la marzocco USA technical bulletin 195

Linea Classic S new “tall cups” version.

June 14, 2024

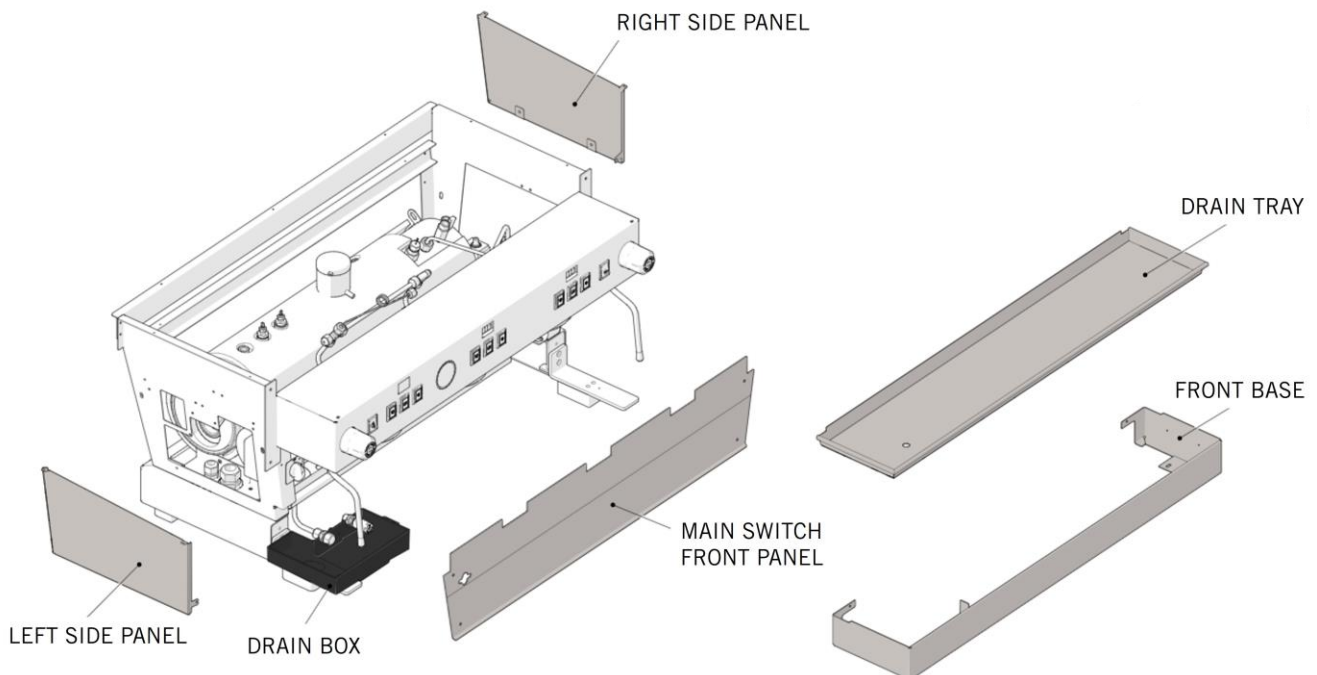
We have recently modified 2,3, and 4 group Linea Classic S to accommodate taller cups.

The change consists in lowering the drain tray by 11mm.

This has also required modifying all components that are indicated in the picture below.

To also facilitate the removal and assembly of the front base, the screw and nut that secure its back side to the machine's frame have been replaced by studs (welded on the panel) and wingnuts.

Retrofitting older machines to the new version, or vice-versa, isn't suggested, and it's only possible by replacing all "high cups" components (see picture above).
